STONEBRIAR ADDITION

WICHITA, SEDGWICK COUNTY, KANSAS

Re: S/D 96-32 STONEBRIAR ADDITION (One Step Preliminary-Final Plat)

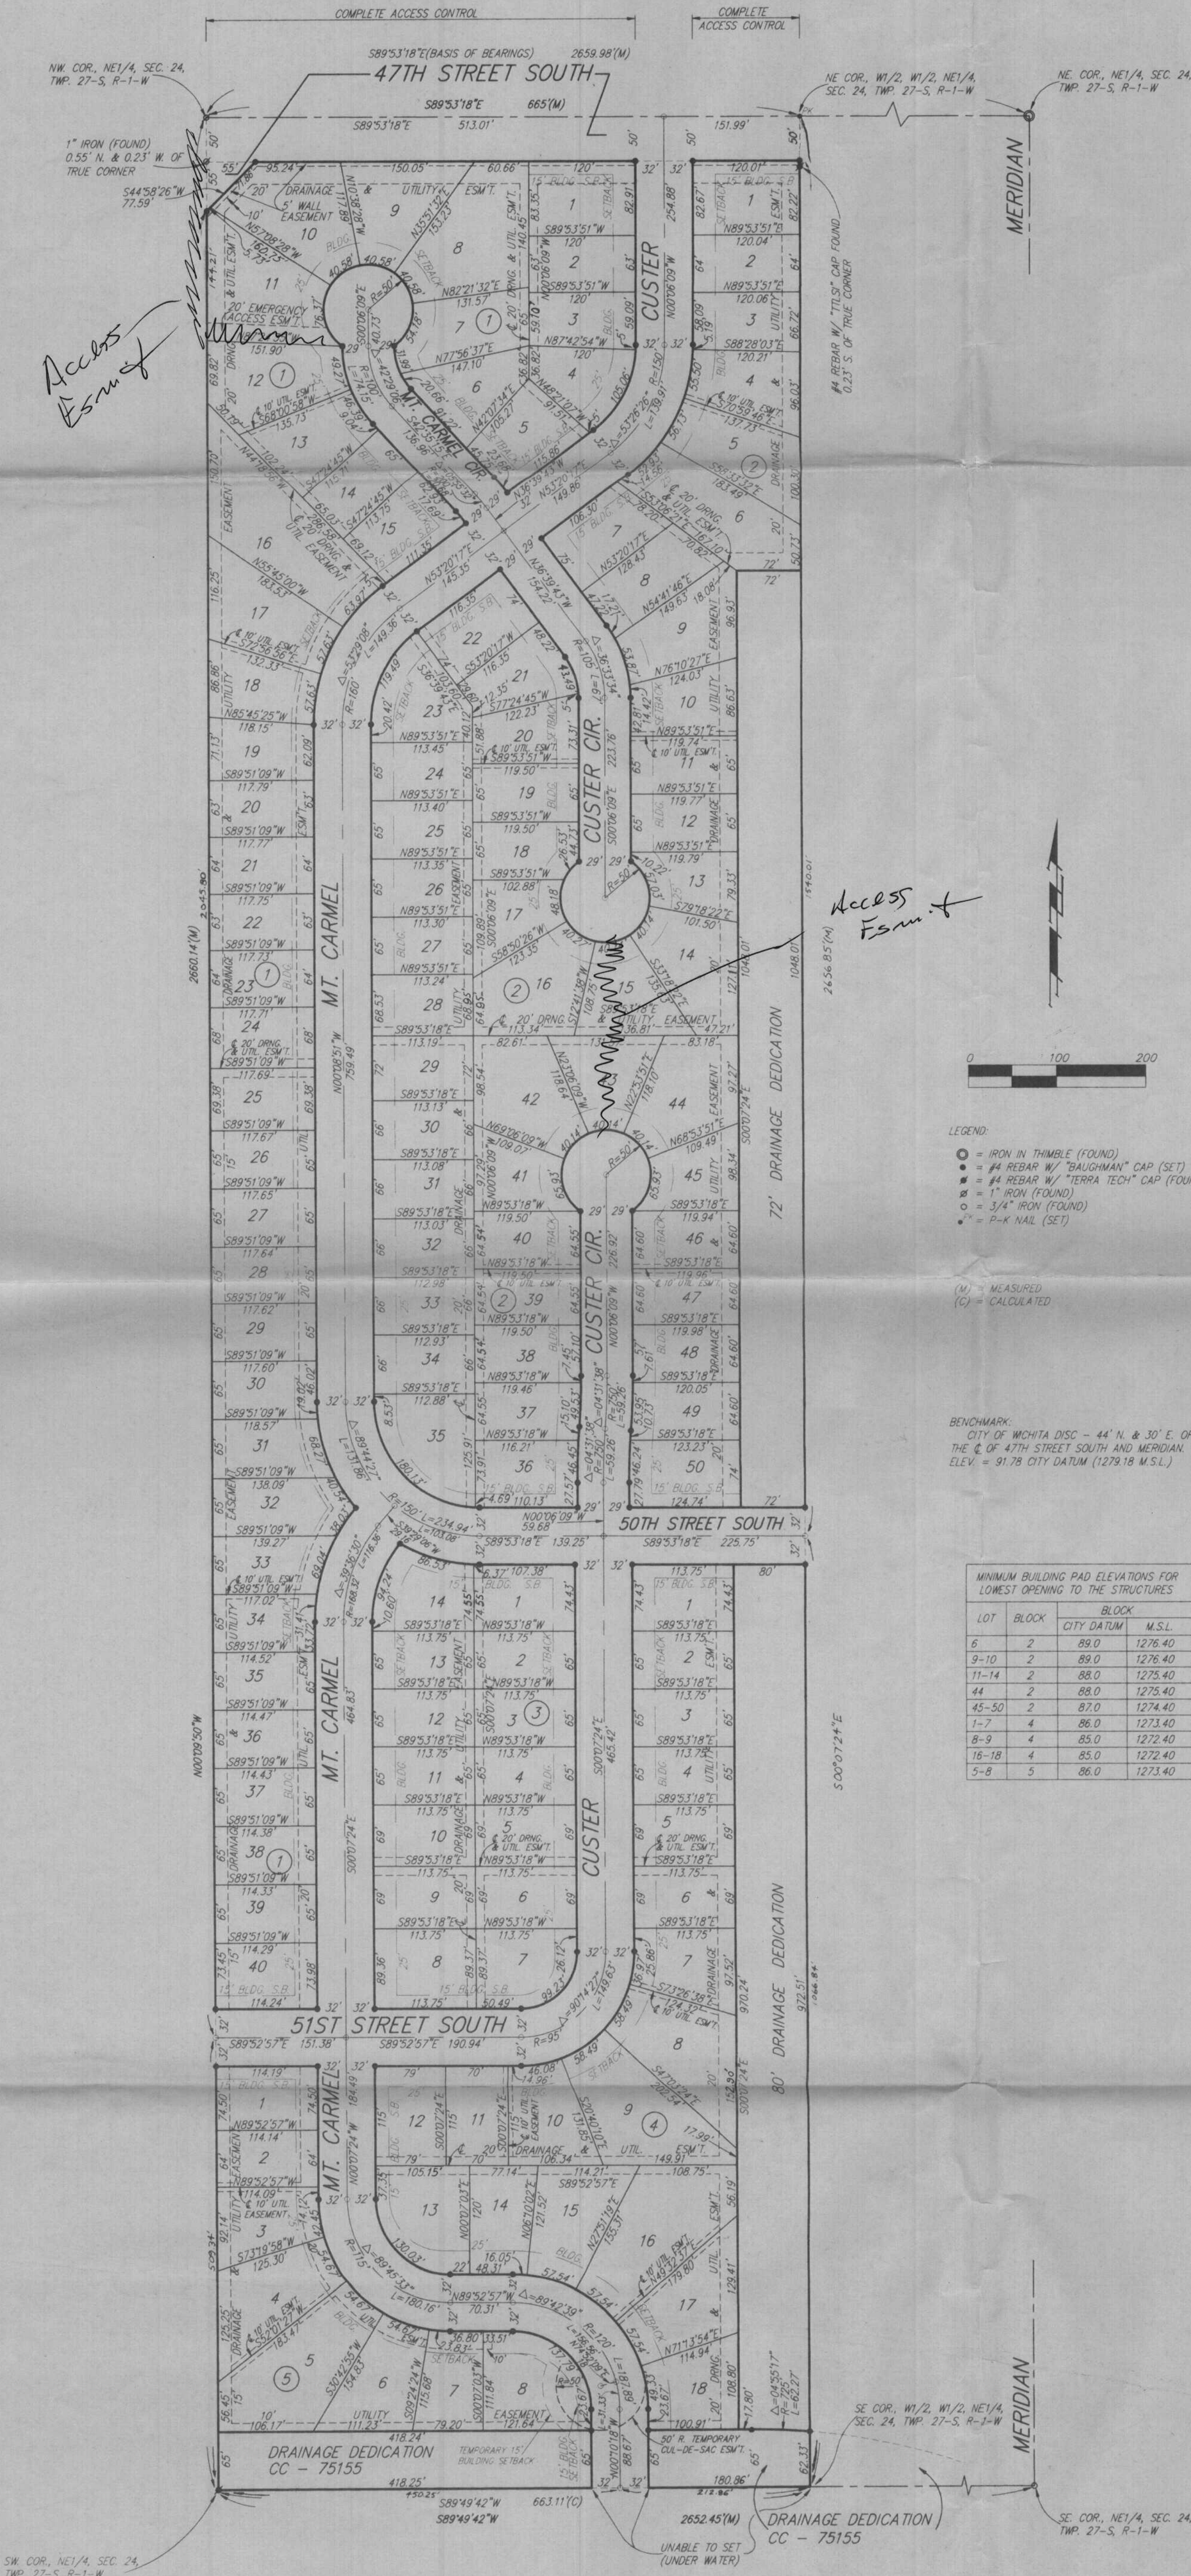
- ☒ A. The applicant shall guarantee the extension of sanitary sewer to serve the lots being platted. This guarantee shall also include any needed off-site extensions.

- ☒ B. The applicant shall guarantee the extension of City water to serve the lots being platted. This guarantee shall also include any needed off-site extensions.

- ☒ C. The applicant shall guarantee any drainage improvements required by the platting of this property.
- ☒ D. The applicant shall guarantee construction of the storm sewers required by this plat.

- ☒ E. The applicant shall guarantee the paving of the proposed interior streets. This guarantee shall include sidewalk along one side of all non-cul-de-sac'd streets, including any street stub sections and streets ending in a permanent or temporary turnaround. Also, this guarantee shall provide for a temporary or permanent turnaround at the site's southern line (for Custer). However, Custer's right-of-way shall in any case, extend to the south line of this plat.

- ☒ F. If determined appropriate by Planning and Traffic Engineering, the applicant shall guarantee accel/decel and/or left-turn lanes to serve this site's one point of entry at 47th Street South. The applicant shall meet with Staff to determine if this improvement will be needed.

- ☒ G. The applicant shall submit a guarantee to participate in any needed reconstruction (paving) of 47th Street South adjacent to this site.

- ~~I.~~ On the final plat tracing, complete access control shall be dedicated to 47th street South from the adjacent lots.
- (J.) Prior to submitting the final plat tracing, the applicant shall meet with City Engineering to determine if a drainage dedication will be accepted or if the involved area needs to be platted as a Reserve. As requested by City Engineering, additional information needs to be provided in regard to the cross section of the drainage way and the available areas either side for access and maintenance of any such dedication. If the area is platted as a Reserve, this plat will be subject to the standard requirements for such Reserve areas. If a dedication is accepted, the plat shall also note that this area is available for public use as a recreational bike and hike, etc. area.

- ~~K.~~ *see note on improvement unit. sheet submitted by appli*
The applicant shall either provide a covenant restricting development of lots south of 50th Street South until another means of acceptable access is provided to this site (public street extended to this plat's indicated street stubs) or an acceptable area is provided for an emergency access easement and a guarantee submitted to install an appropriate all-weather driving surface. The applicant is encouraged to consider such an easement in conjunction with the above noted drainage dedication/Reserve.

- (L.) Based on the platting binder, a blanket pipeline easement apparently covers this site. Prior to this plat being released for recording, the applicant shall provide proof that this easement has been released. If confined, and located any where on this site, this plat will be subject to the standard requirements concerning pipelines and pipeline easements.

- ~~M.~~ The preliminary plat is presently indicating 3 of the plat's 4-corners as being tied to the N.W. corner of this quarter section. On the final plat tracing, any such corner references shall note a proper corner (NE, SE, etc.).

- T. The final plat shall indicate the utility easements requested by K.G.& E. and Southwestern Bell which are indicated on the enclosed "marked" copy of the plat. The applicant is also encouraged to discuss with the utilities (KG&E and S.W. Bell) the appropriateness of platting 20-foot, combined drainage and utility easements for this site. If necessary, the final plat shall revise such easements (increase their widths, drop drainage use, etc.)
